B5 Department of Primary Industries

This chapter addresses issues raised by the NSW Department of Primary Industries (DPI).

Figure B5-4 Areas potentially in luenced by saltwater intrusion

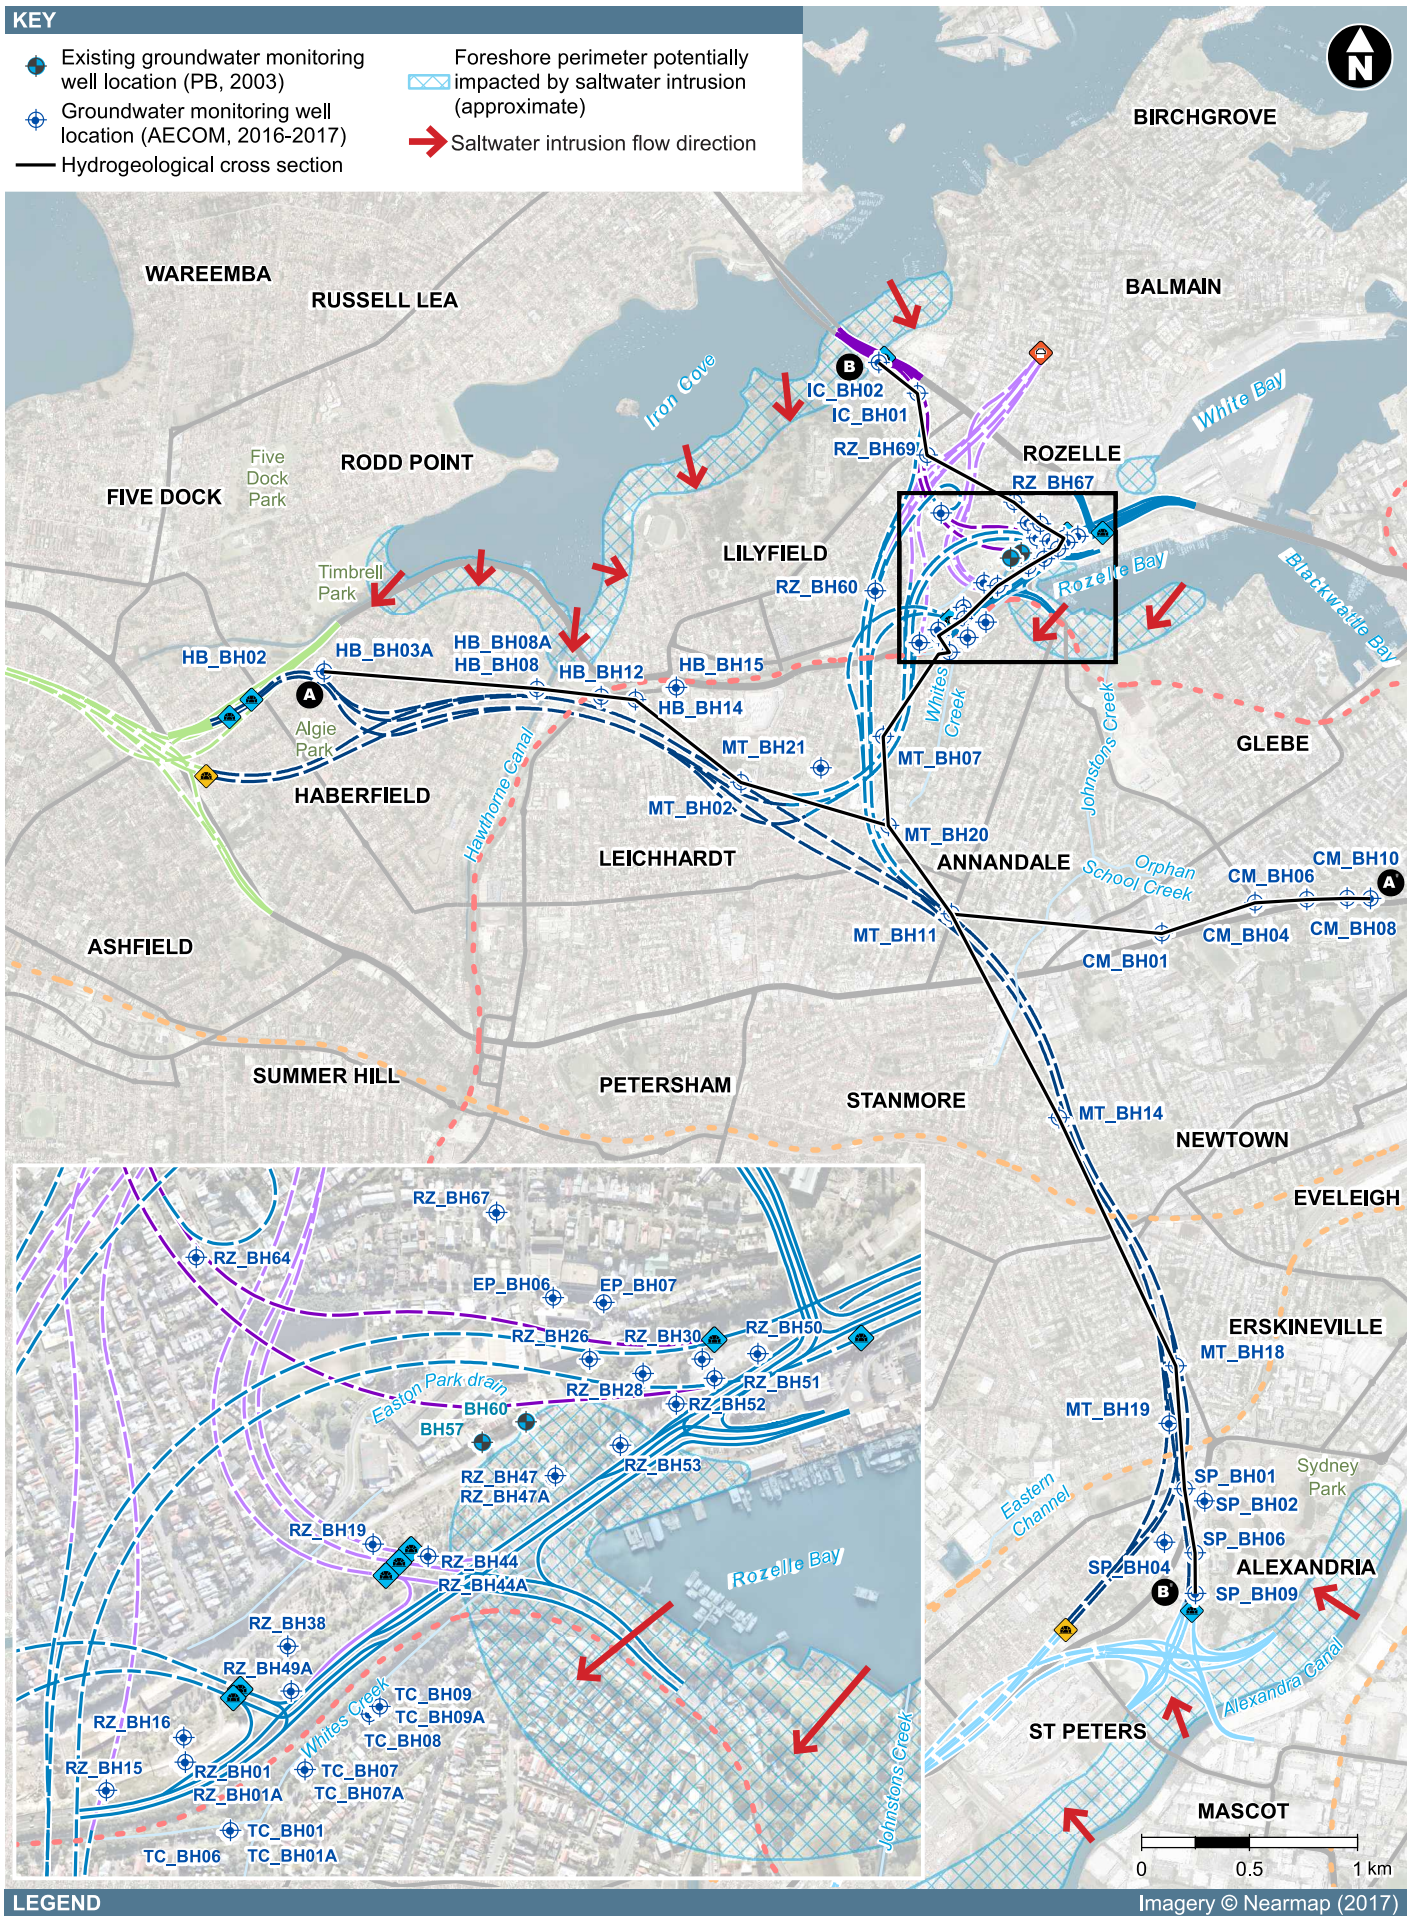
DPI considers that the largely untanked (unlined) sections of tunnel which require continuous dewatering will exceed the Level 1 water quality criteria under the Aquifer Interference Policy and will trigger Level 2. The proponent should demonstrate where salt water intrusion from tidal areas will occur and then re-analyse these impacts on sensitive uses of the groundwater. The proponent should also confirm if the particle tracking component of the groundwater model was sufficient to analyse these overall impacts of salt water ingress to the tunnel ecosystems along this tidal fringe.

Four key areas have been identified that may be subject to saltwater intrusion as shown on **Figure B5-4** and **Figure B5-5** (refer to Figure 3-2 and Figure 2-3 of Appendix T (Technical working paper: Groundwater) of the EIS). These figures show the direction of flow of saline surface water towards the tunnels and the initial area of influence. These identified areas are:

- Lilyfield and Rozelle on the south eastern edge of Iron Cove
- Rozelle west of White Bay
- Rozelle west of Rozelle Bay
- St Peters north-west of Alexandria Canal.

Following construction, it is recommended that existing monitoring wells between these foreshore areas and the project tunnels are identified and are added to the groundwater monitoring network to monitor for any changes in groundwater quality that could be attributed to saltwater intrusion.
